Re: Tri-County Regional Vocational High School  
Con-Com and Peer Review Response

SCI File # 52033.02

May 23, 2024

This memo is a response to the Peer Review comments received on May 1, 2024, prepared by Elyse Tripp, Scientist – BETA Group, Inc, and Jonathan Niro, Senior Project Scientist – BETA Group, Inc., regarding the Notice of Intent submission package dated May 2024, for the above referenced project. The following comments from Peer Reviewer are in italics with our response in “Bold”:

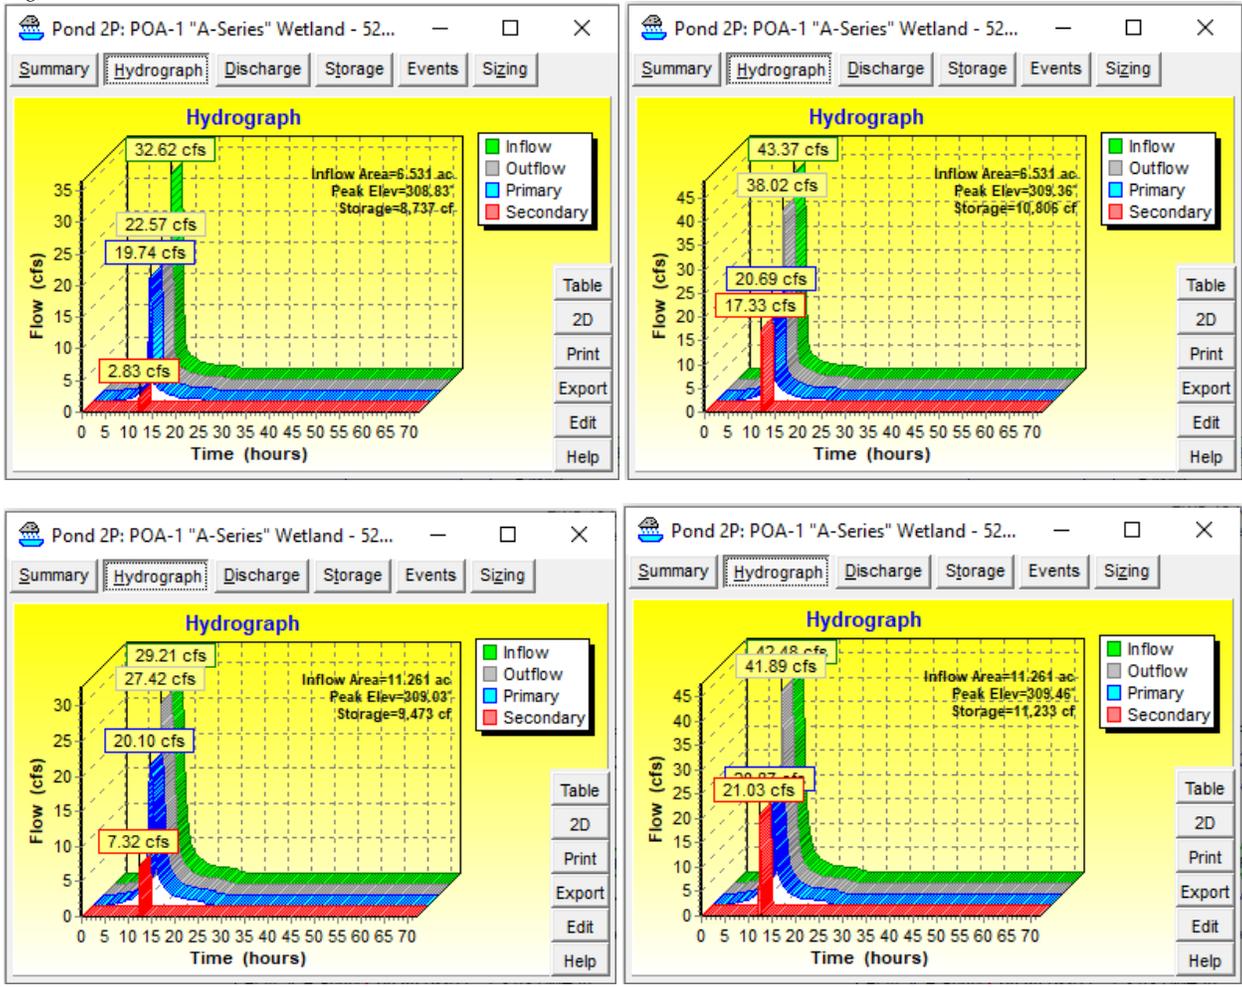
*Comment 31: Provide table comparing pre- and post-development runoff volumes for each watershed area to evaluate flooding impacts to wetland resource areas and downgradient properties.*

**SCI Response:** Refer to Response to Comment SW16 for table comparing pre- and post-development runoff volumes for each watershed area. To evaluate the impacts for increasing volumes to the “A-series” and “B-series” wetlands, the wetlands were included as Ponds in both the existing and proposed HydroCAD models. Given the surface contours and volume available at each wetland, the model shows some overtopping at the “A-series” wetland in the existing condition at the 25- and 100-year storm events. Reviewing existing topography, theoretical runoff that overflows from the “A-series” wetland appears to run down the vegetated slope alongside Tri-County Drive to the inlet upgradient from the existing access drive. Any flows that do not get captured by the inlet appears to be directed on to Tri-County Drive or continue down and alongside Tri-County Drive. In the proposed condition, it appears that runoff will overtop the “A-series” wetland also during the 25- and 100-year storm events, but to a greater degree than existing. “A-series” Wetland Overflow in Existing (top) and Proposed (bottom) at 25-year (left) and 100-year (right) Storm Events
